DELEGATED APPLICATION REPORT

App Ref: PL/26/0771 Householder planning permission

Address: 12B NORTHCOURT AVENUE, READING, RG2 7HA

Proposal: Conversion of existing garage into habitable space including refurbishment works to existing garage roof and ground floor extension across the rear of the property.

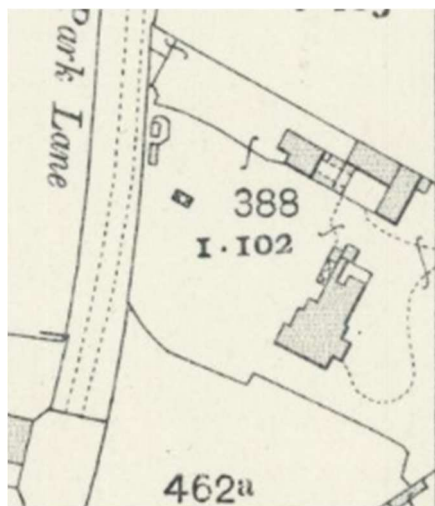
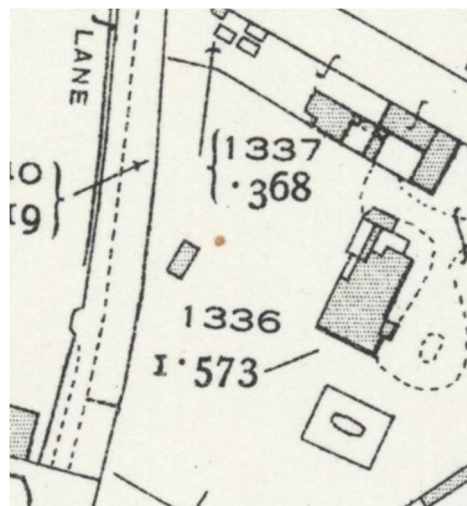
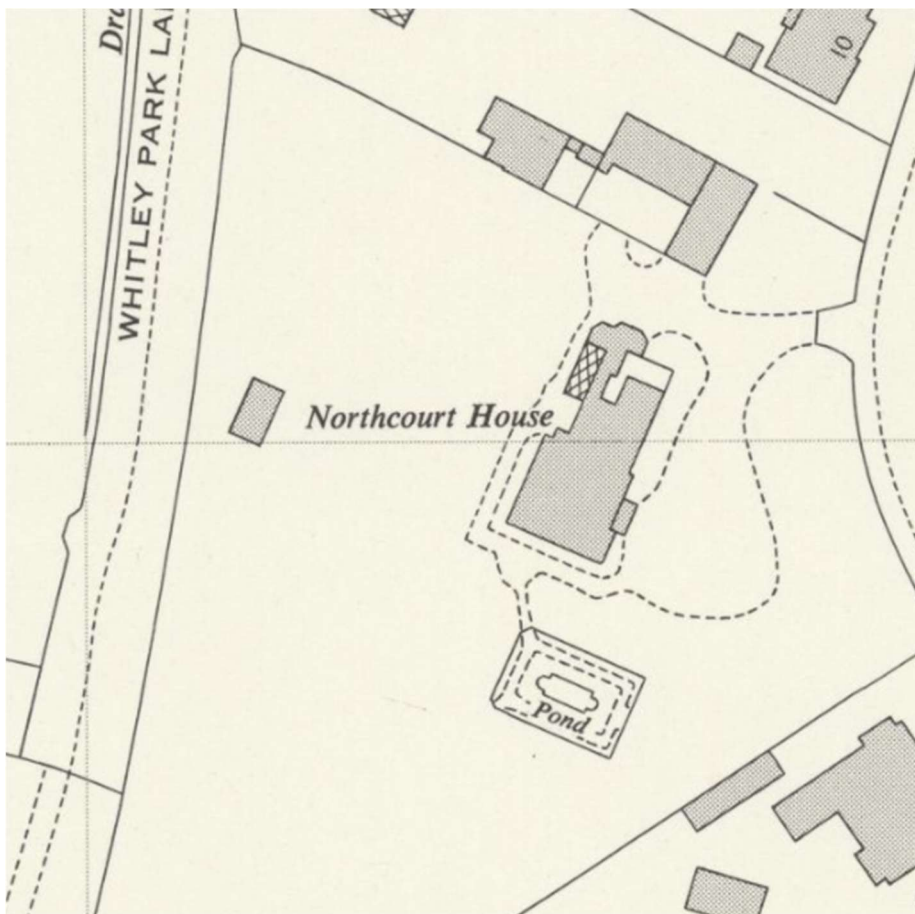
The building is not considered to be a non-designated heritage asset (I did quick research and could not find anything about the architect or builder). But from the historic map regression, I noted that the building retains its footprint and external features.

The proposal would replace the existing garage with a two-storey extension. Although I proposed the ridge height lower than the main building and the roof form could be accepted, due to the size and additional massing, the proposal would not be subservient or subordinate to the host building. T

he building is well set back from the main road, mainly screened by natural elements; as such, losing one chimney could be ok. However, I think the proposal radically changes the relationship of the main building with the road as well as the new element: the proposed porch on the newly created long elevation facing Northcort Avenue would result in dominance of the two-storey extension rather than the host building.

Because of the proposed internal layout, the host building would lose its dominance as it would have service units, not the main rooms. (I think another application for creating of a driveway from Northcort will be submitted.) I think the length (depth) of the extension should not exceed that of the main building. It should not constitute new elements with noticeable massing (porch).

Due to its two-storey nature, the proposal, due to its footprint, scale, massing, design and appearance, would dominate the application site, would not be subordinate or subservient addition. I think use of matching materials is ok, but it still requires revisions. If this would be a NDHA I would add the change in the historic relationship of the subject building with Northcourt Avenue and No. 12 as well.

The main entrance of the host building should be kept (should serve as the main entrance), the footprint and massing should be reduced. Otherwise, the extension would be perceived as the main building.

Planning officer note: On reviewing the amended and final proposed plans, the conservation officer confirmed the proposed development was acceptable in terms of conservation and harm to the original building fabric.

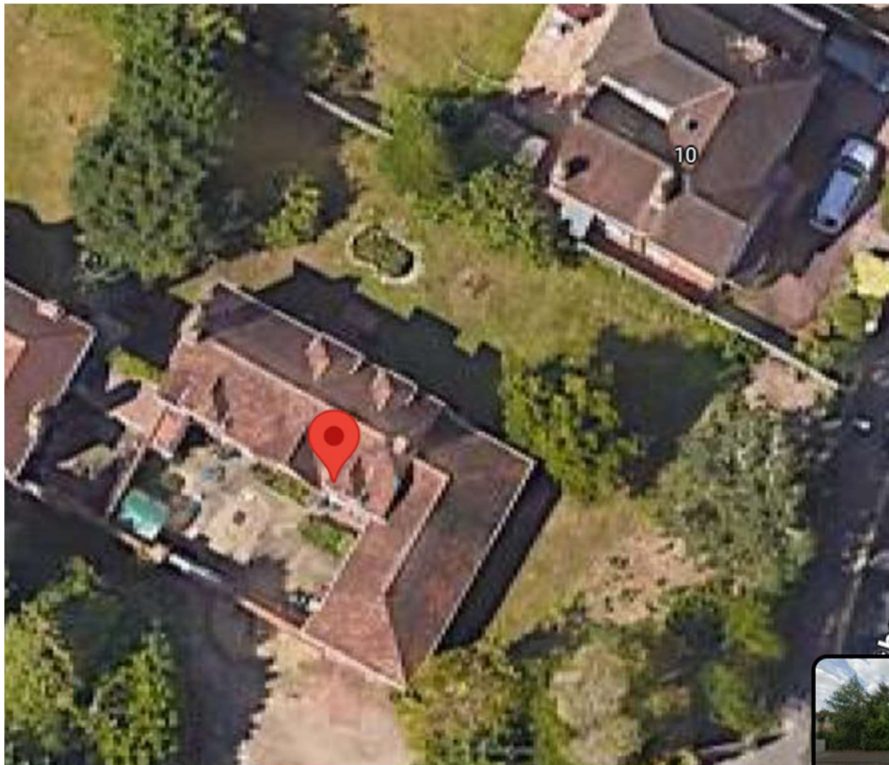
The Arb report does not reflect the proposals on the latest plans, and it can be determined when comparing the Block Plan with the TPP that the rear extension is likely right on the edge of the canopy of T10 Oak:

This change justifies a request for an updated AIA and TPP to assess the impact on T10 – it is likely to need facilitative pruning for clearance to allow for the build (the tree canopy is low according to the survey) and the tree protection fencing may need to be set back (under the canopy) for construction access, hence with ground protection also then specified.

Further to my comments of 27/8/26 I note that a revised **Arboricultural Report Reference:**

MW.2604.NAR.AIA Date: 21 April 2026 Revision: B issued 15 September 2026 has been submitted to address my comments.

I can confirm that the report satisfactorily addresses my queries. **Condition L7A** is required to secure development in accordance with the attached (which should also be listed as an approved doc).
